UNITED STATES PATENT AND TRADEMARK OFFICE

APPLICATION NO.	FILING DATE	FIRST NAMED INVENTOR	ATTORNEY DOCKET NO.	CONFIRMATION NO.
10/727,006	12/03/2003	James D. Castillo	INVAT-098A	4499

Office Action Summary	Application No. 10/727,006	Applicant(s) CASTILLO ET AL.	
	Examiner Shumaya B. Ali	Art Unit 3743

DETAILED ACTION

**FIG. 5**

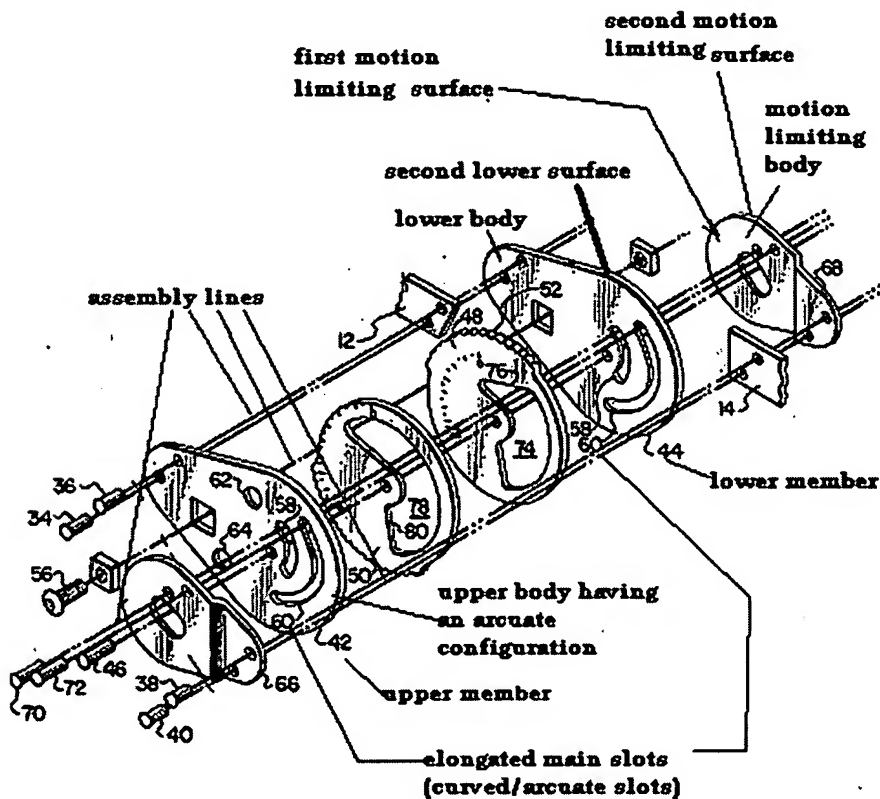
3. **As to claim 1, Bledsoe discloses** a hinge system for stabilizing the human knee which stimulate the movement of the human knee and which can be utilized to restrict the range of motion of the knee to any desired range (see col.1 lines 5-9) having: a flexion-extension regulating device (see fig.5 reference objects 42 and 44) having an upper member (see fig.5 reference object 42) and a lower member (see fig.5 reference object 44) attached to each other in a manner defining a gap (as depicted in fig.5, 2 members

6. **As to claim 5, Bledsoe discloses** the hinge system of claim 1 wherein the upper member comprises an upper body having a generally arcuate configuration (see labeled fig.5).

7. **As to claim 6, Bledsoe discloses** the hinge system of claim 1 wherein the lower member comprises a lower body having a configuration sized and configured to substantially correspond with the end portion of the upper strut (see labeled fig.5)

9. **As to claim 8, Bledsoe discloses** the hinge system of claim 1 wherein the upper member comprises an elongated upper slot (see fig.5 reference object 60 formed within 42) and the lower member comprises a elongated lower slot (see fig.5 reference object 60 formed within 44), the upper and lower slots being substantially aligned with each other to form the elongated main slot (a main slot will inherently be defined when the 2 members are aligned according to the assembly lines of figure 5).

10. **As to claim 10, Bledsoe discloses** the hinge system of claim 1 wherein the motion limiting member has a motion limiting body (see labeled fig.5) with a first motion limiting surface the motion limiter extending outwardly in a generally perpendicular relationship with respect to the first motion limiting surface (motion limiter 70 and 72 are perpendicularly disposed in the motion limiting member and extends from the second motion limiting surface to the first motion limiting surface and further extended to be engaged with in the slots 58 and 60 as depicted in fig.5 following the proper assembly lines),

11. **As to claim 11, Bledsoe discloses** the hinge system of claim 10 wherein the lower member has a lower body with a second lower surface (see labeled fig.5), the first motion limiting surface being connected to the second lower surface (see fig.5 connected via reference objects 70,72, and 46) in a manner as to align the motion limiter within the elongated main slot.

12. **As to claim 12, Bledsoe discloses** the hinge system of claim 10 wherein the motion limiter is a flange (dictionary definition of a flange is a protruding rim, edge, rib, or collar, as on a wheel or a pipe shaft, used to strengthen an object, hold it in place, or attach it to another object. Pin 72 is protruding edge engaged in slots 60 as depicted in fig.2 is inherently capable of holding the reference objects 42 and 44 in place. Therefore, the pin 72 is considered a flange portion of the motion limiting member 66, see fig.5) fabricated from metal (see col.4 lines 46-48).
